# **USE ON REVIEW REPORT**

► FILE #: 7-B-21-UR	AGENDA ITEM #: 29
	AGENDA DATE: 7/8/2021
► APPLICANT:	MBCOMMONS, LLC
OWNER(S):	Karen Speegle
TAX ID NUMBER:	105 057 & 058 View map on KGIS
JURISDICTION:	County Commission District 6
STREET ADDRESS:	0 Middlebrook Pk.
► LOCATION:	Southwest side of Middlebrook Pike, northwest of N. Cedar Bluff Road
APPX. SIZE OF TRACT:	5.29 acres
SECTOR PLAN:	Northwest County
GROWTH POLICY PLAN:	Planned Growth Area
ACCESSIBILITY:	Middlebrook Pike is a major arterial with a landscaped median and 74-ft pavement width within a right-of-way that varies in width from approximately 94 ft to approximatelyt 138 ft at this location.
UTILITIES:	Water Source: West Knox Utility District
	Sewer Source: West Knox Utility District
WATERSHED:	Turkey Creek
► ZONING:	OB (Office, Medical, and Related Services)
EXISTING LAND USE:	AgForVac (Agriculture/Forestry/Vacant Land)
PROPOSED USE:	Multi-family Development

Approve the development plan for a multi-family development with up to 120 dwelling units and a maximum height of approximately 52 feet, subject to 8 conditions.

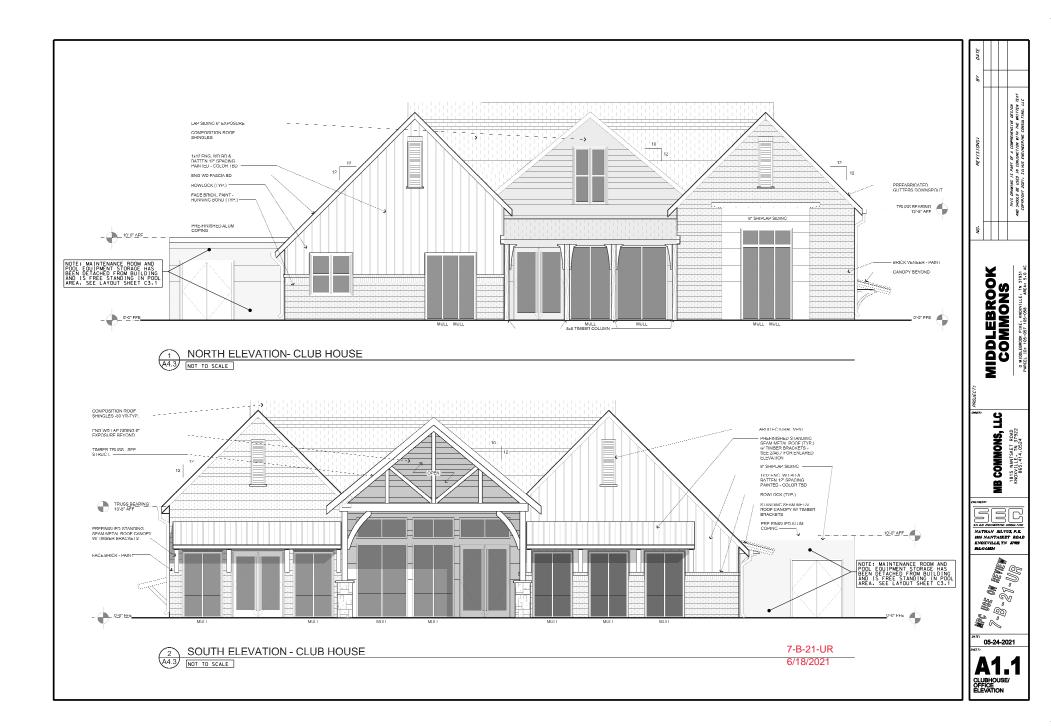
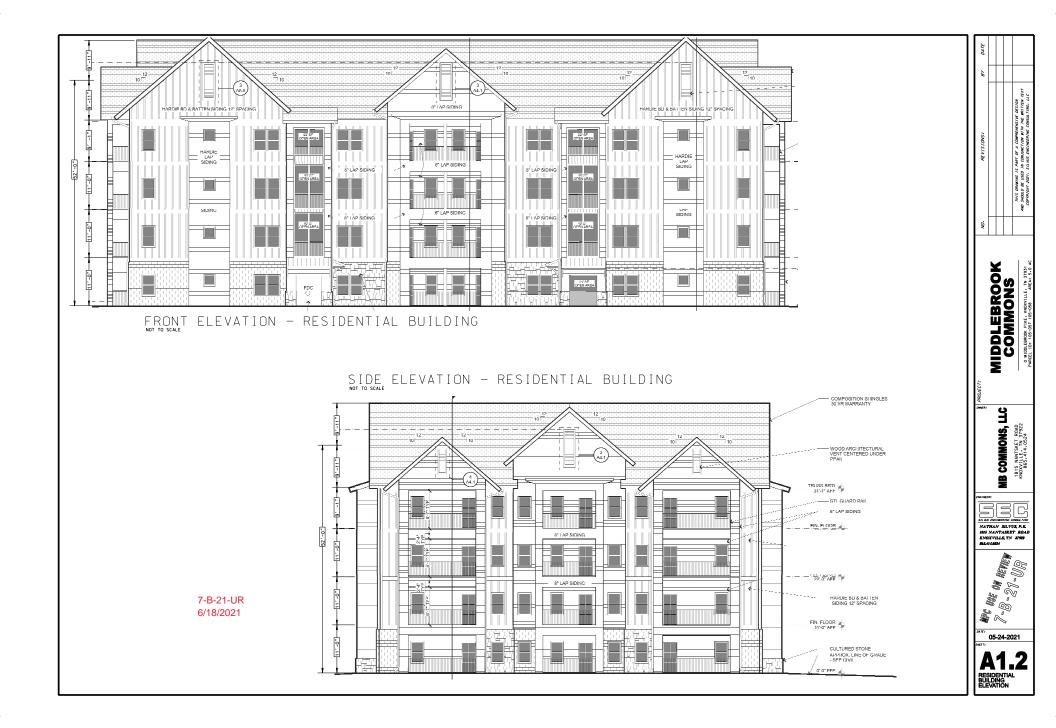
Access to the site is from Middlebrook Pike and is a shared driveway with the Dollar General Market store. The and the applicant proposes three different options (scenarios) for improvements to Middlebrook Pike to improve access to the site (see sheet C3.3). Options 1 and 2 propose a new median opening, with option 1 providing full access and option 2 providing left-in only access. Option 3 does not include a new median opening but does include an eastbound right turn lane. Middlebrook Pike is a TDOT facility so any improvements to the road must meet their standards and obtain their approval for permitting. To date, TDOT has only agreed to allow Option #3 because the new median opening does not meet the minimum separation standard between median openings.
